Mirage MD24, MDD24

Range Modifications

MD24 - IP44 Version

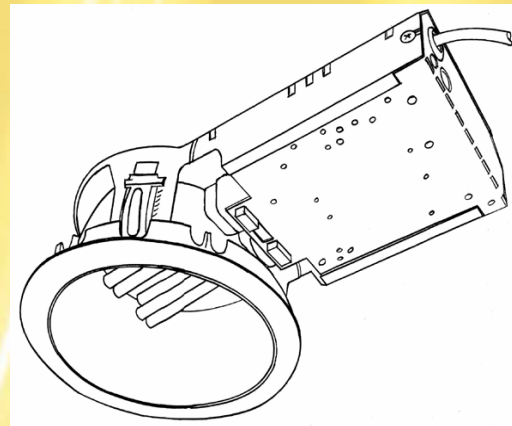
Product has been increased in height and utilises the Cat2 plain silver reflector, replacing the diamond faceted.

- Increased height of plain reflector (172mm) makes all lamp and gear options available with IP44.
- Diamond faceted reflector no longer available for IP44.
- Emergency gear remains as remote.

MD24/MDD24 - Gearbox

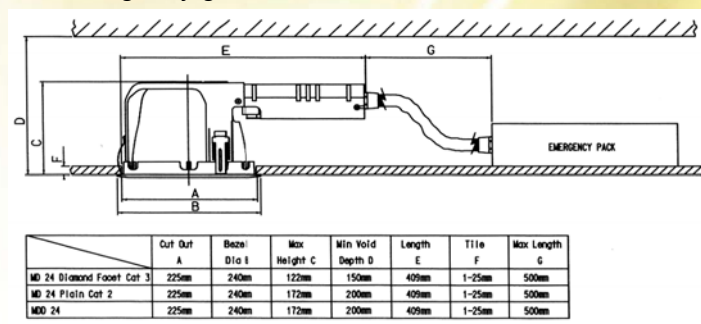
MD24/MDD24 gearbox has now been standardised to accept all gear types internally. This removes the need for remote gearbox and short head on dimmable and MDD24 versions.

- Construction has changed – folded Zintec replaces aluminium extrusion.
- Emergency gear remains as remote.
